Re: Keeley Park – Phase II

Additional Services for Scope Change

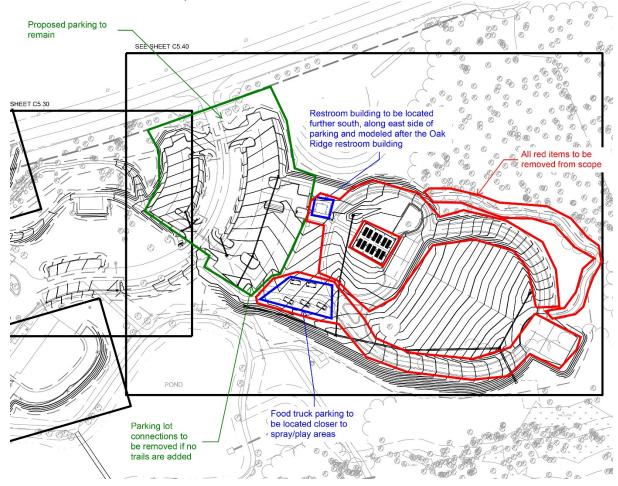
It is our understanding that the City of Greensboro would like to have some changes made to the Keeley Park design prior to final permitting and construction documents. The following exhibit shows the extent of these changes on the site plan. The red items are to be removed, the green items are to remain, and the blue items are to remain in scope in different locations than shown:

- Removal from all plan sheets the following items:
 - Pad for show wagon
 - Trail through woods north of Amphitheatre lawn
 - Amphitheatre lawn
 - Hardscape loop around the Amphitheatre lawn
 - Drive access from the eastern parking lot to the Amphitheatre lawn
 - o Notations for the future beginner bike trail, as it is under construction
 - Notations for disc golf, as it is under construction
- Relocation of the following elements:
 - The food truck area will be relocated from the Amphitheatre area,

likely to the east of the sprayground building.

- Modifications of the parking/driveway will be made to accommodate this change, including site layout, grading, and drainage.
- The restroom/shelter building will be relocated east of the new larger parking lot, likely south of its current location

- The Festival Field will move from the Amphitheatre area to the area west of the upper parking lot/community garden area.
 - The site could be upgraded for a small amphitheatre in the future.
